SUBJECT: PLANS AND PROPOSAL ADDENDUMS

PROJECT: F 2B24(123)

CONTROL: 0814-01-036

**PROPOSAL ADDENDUMS**

**FM 422  
 CULVERT  
 PROFILES**

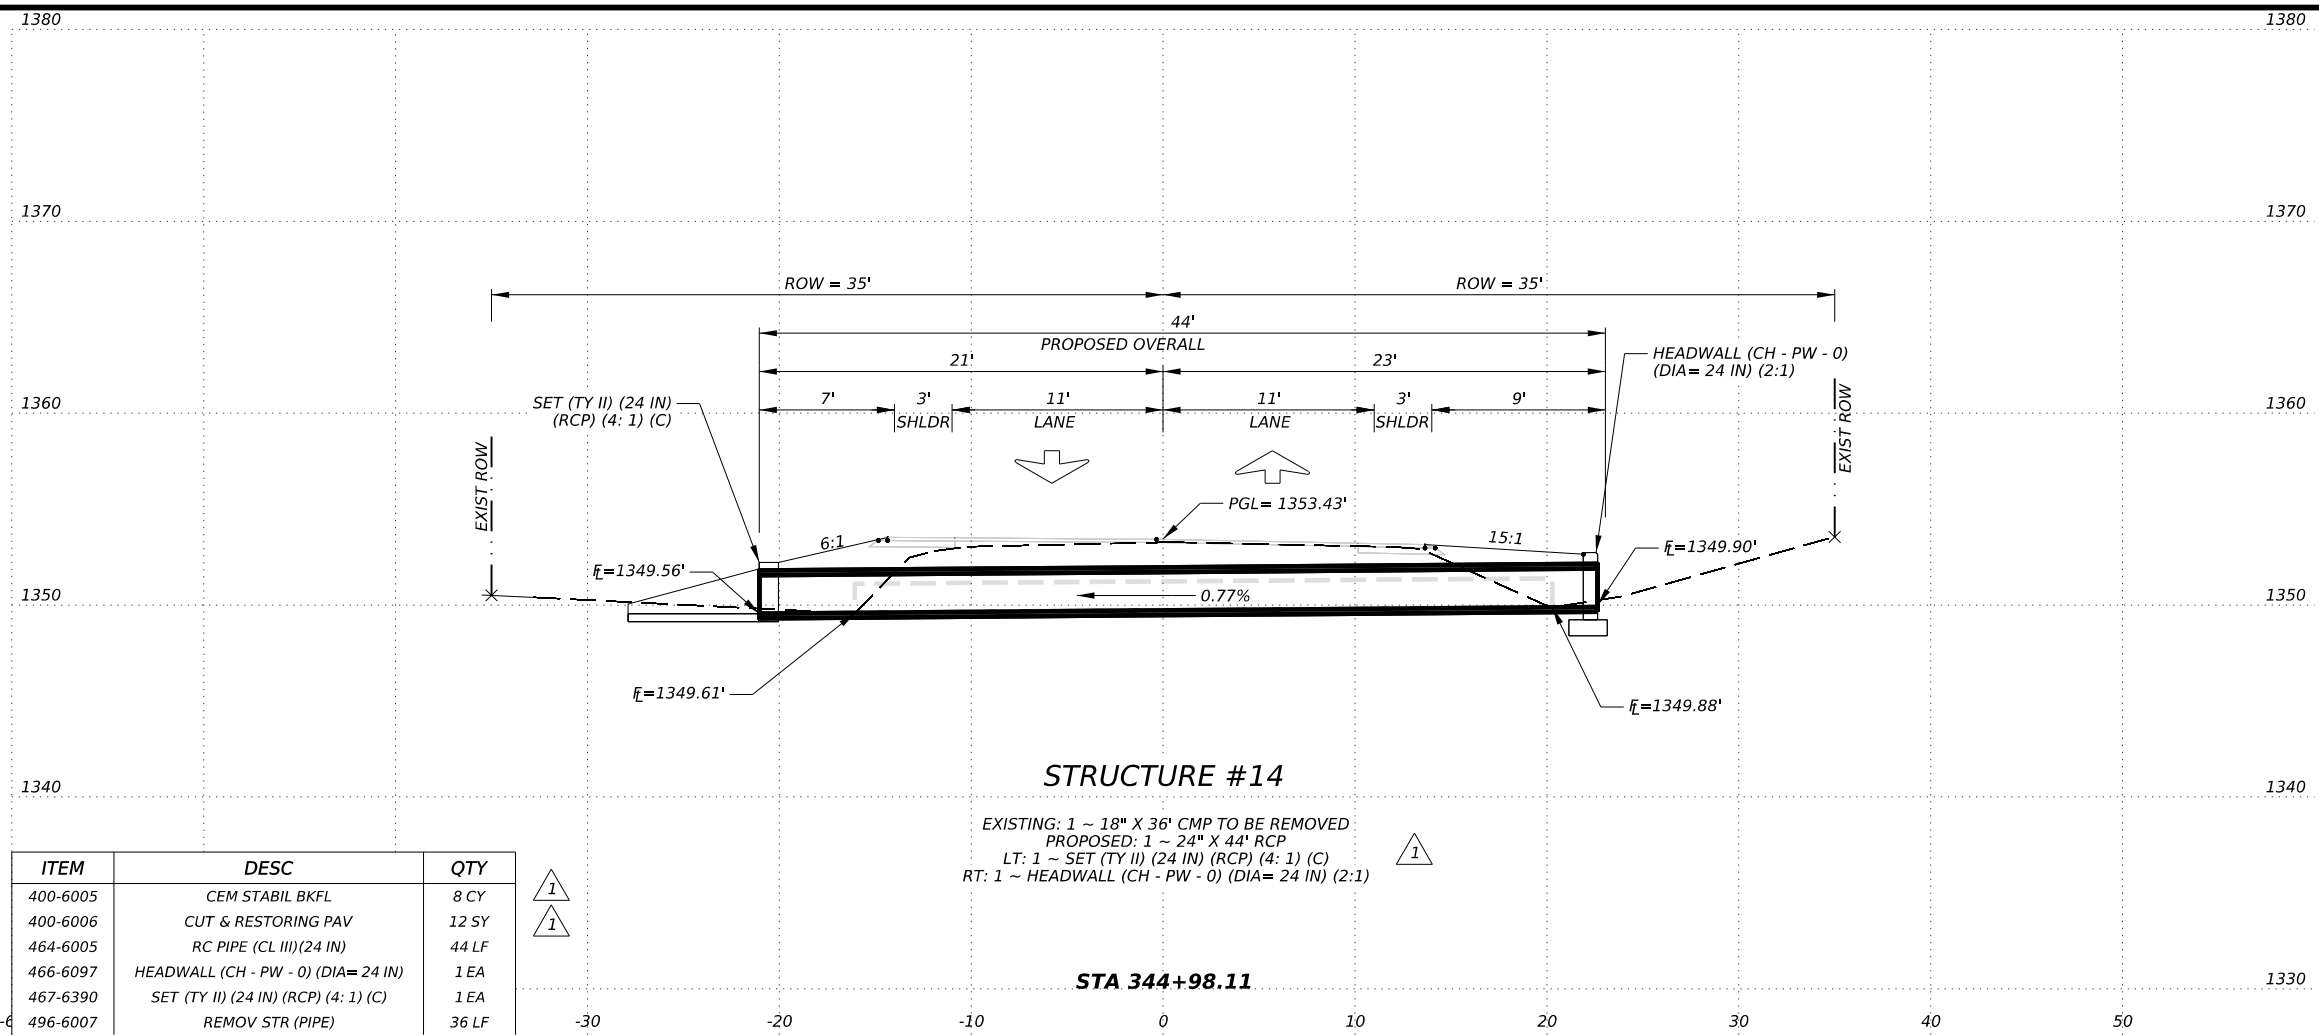
REVISE SHEETS 8, 11-12, 13-15, 74, and 76-82, DUE TO CHANGES ABOVE

REVIS 5/23/24

ITEM	DESC	QTY
400-6005	CEM STABIL BKFL	8 CY
400-6006	CUT & RESTORING PAV	12 SY
464-6005	RC PIPE (CL III)(24 IN)	44 LF
466-6097	HEADWALL (CH - PW - 0) (DIA= 24 IN)	1 EA
467-6390	SET (TY II) (24 IN) (RCP) (4: 1) (C)	1 EA
496-6007	REMOV STR (PIPE)	36 LF
